Re: **Market Street Center Shell Building**
291 and SW Market Street
Lee's Summit, MO

Deviation Report

Project Name: MARKET STREET CENTER SHELL BLDG

As Built Construction Confirmation

POLE BASE DETAIL

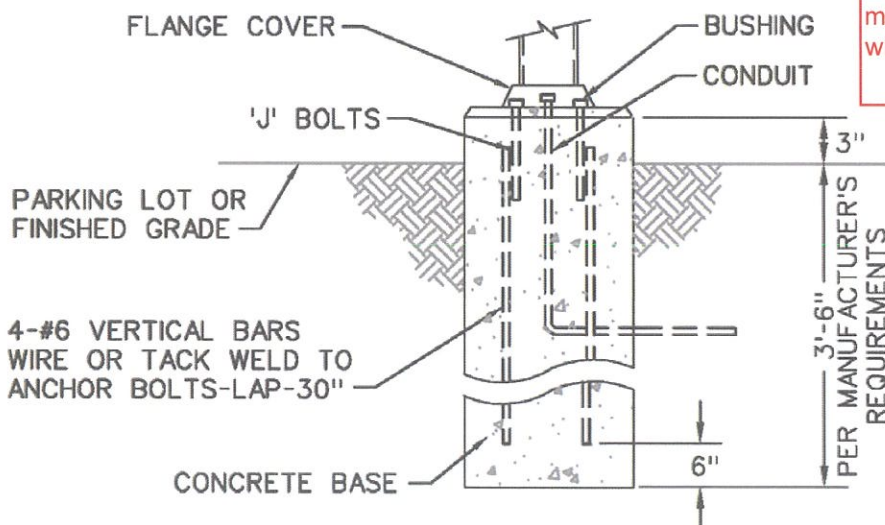
Observed reinforcing steel for lightpole bases West of building.

Anchor bolts were wet set and not tied to vertical reinforcing. Anchor bolts lap with vertical reinforcing was approximately 2 ft as opposed to 30" per plans.

Anchor Bolts supplied by light pole manufacturer were only 30" vertically long with j hook, which did not allow for 30" lap with 4" bolt projections at top

Anchor Bolts were not tied to the vertical reinforcing

Vertical reinforcing installed per plans; also 3-#3 rings installed at top, middle, and bottom

Action Taken: Accepted by September 20, 2022 Memorandum from Joe Stewart.

Please be advised the attached light pole base detail has been reviewed and the variations in installation have been found to be acceptable. Please accept this letter as certification of compliance for each location.
